REFL165 modification by KA Oct. 17, 2011

Title LSC Photodiode		Date Last Modified: 17-May-99	
LIGO Laboratory California Institute of Technology Massachusetts Institute of Technology			
Size: B	DCC Number: D980454-01-C	PCB / SCH Revision: B / 1	Engineer: J. Suina D. Ouimette
File: S:\SYSTEMS\LSCPHOTOD-1\FINAL\SCHEMA-1\8045401A.SCH		Date: 12-Aug-1999	Time: 16:56:25
			Sheet 2 of 2

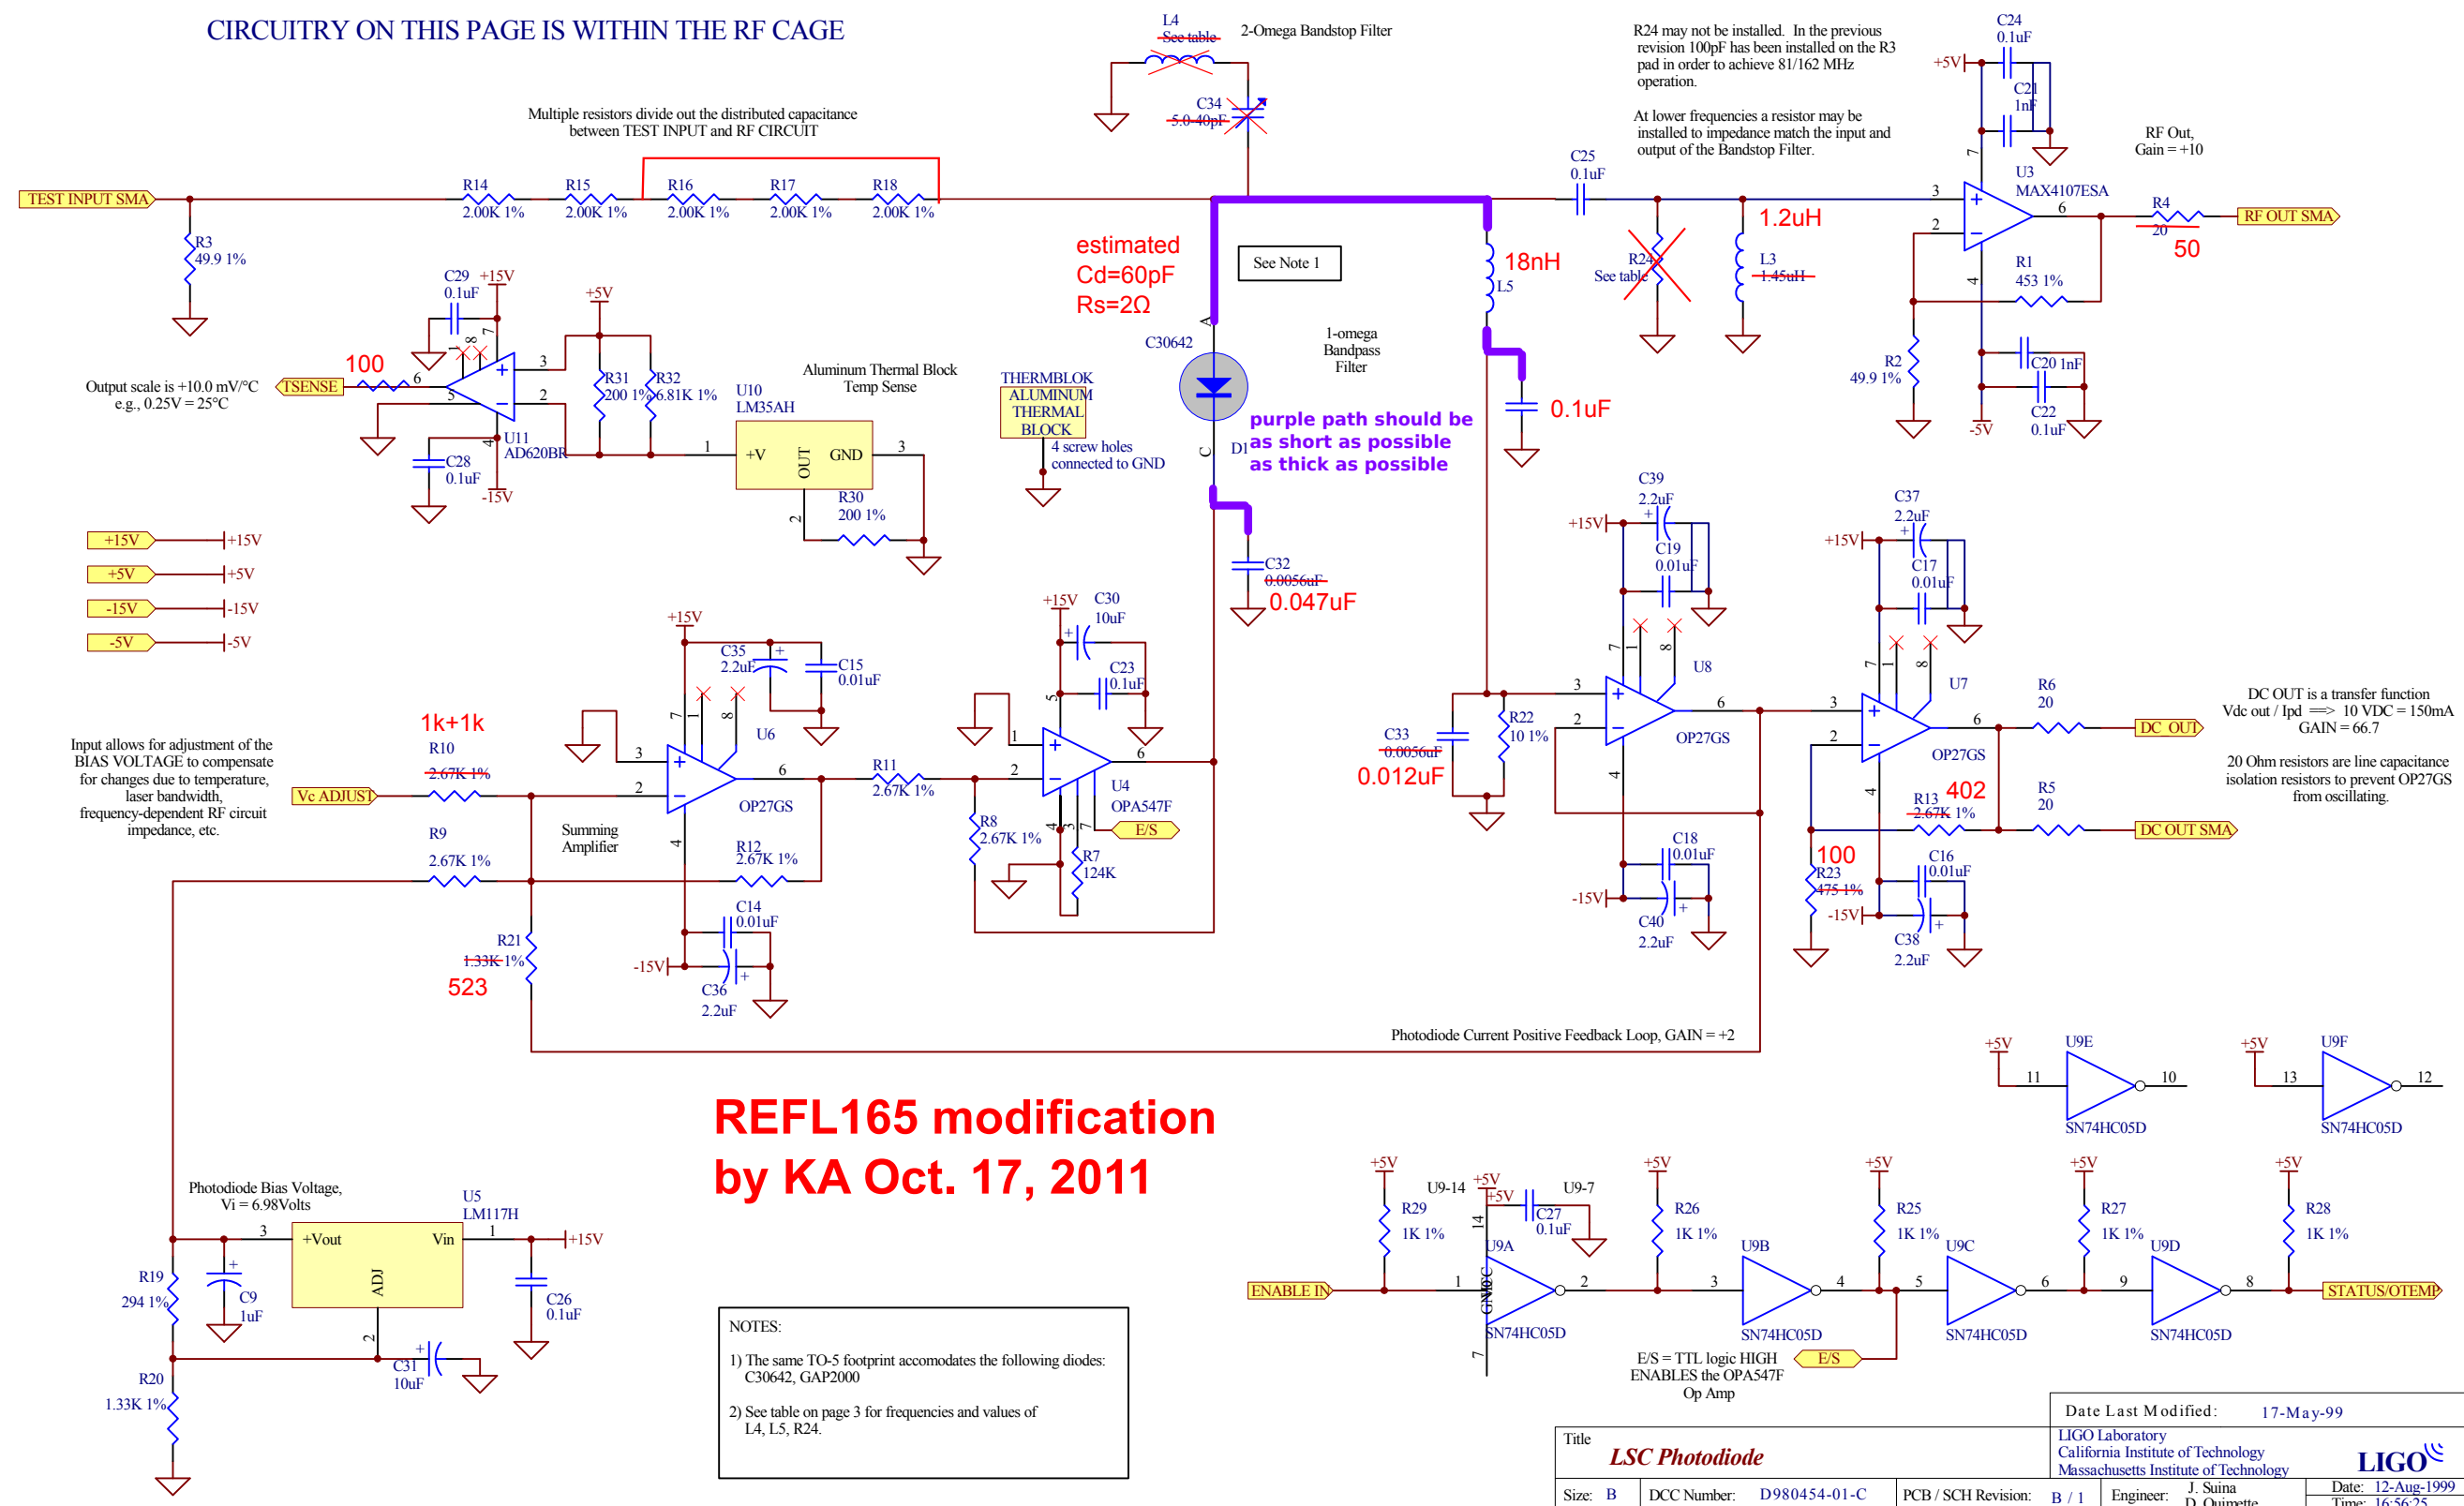
estimated Cd=60pF
Rs=2Ω

purple path should be as short as possible as thick as possible

R24 may not be installed. In the previous revision 100pF has been installed on the R3 pad in order to achieve 81/162 MHz operation.
At lower frequencies a resistor may be installed to impedance match the input and output of the Bandstop Filter.

DC OUT is a transfer function
Vdc out / Ipd ⇒ 10 VDC = 150mA
GAIN = 66.7
20 Ohm resistors are line capacitance isolation resistors to prevent OP27GS from oscillating.
